ADDENDUM NO. 1

**VA SORCC
REPLACE B248 CHAPLAIN SERVICE**

July 20, 2015

LIGHT MOUNTING BAR

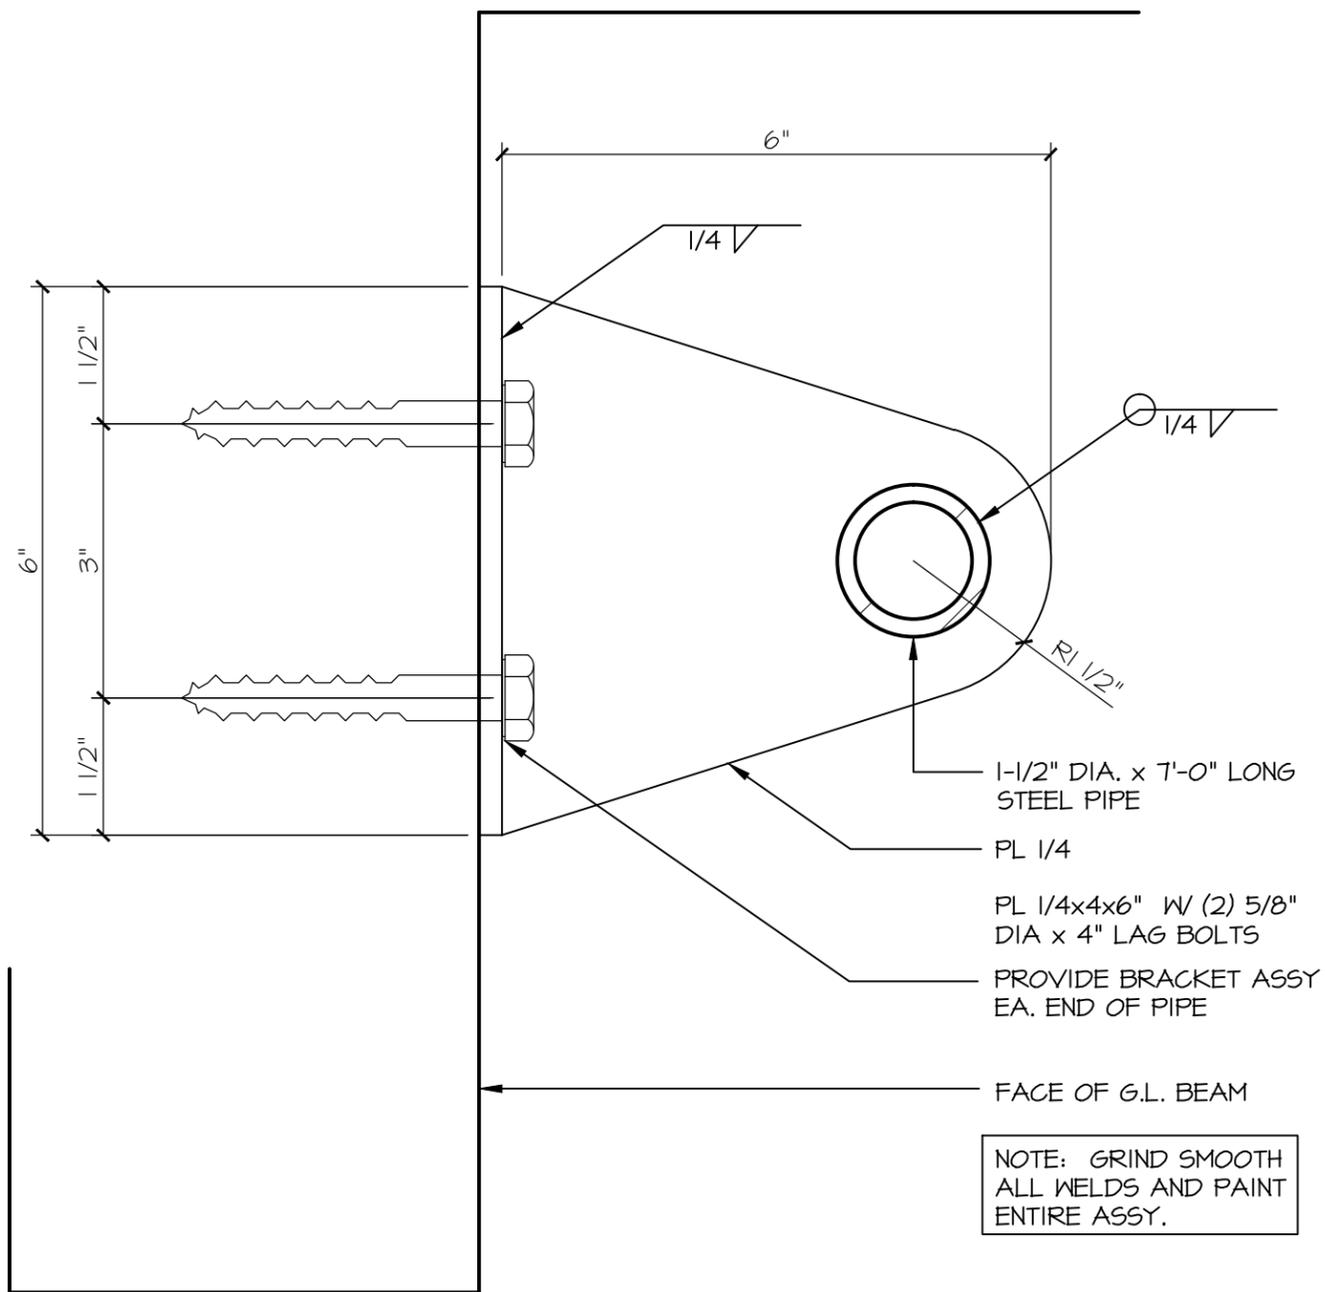
Drawing SD-3 (attached) details the mounting bar for light fixture K, the theater lights in the Chapel Sanctuary
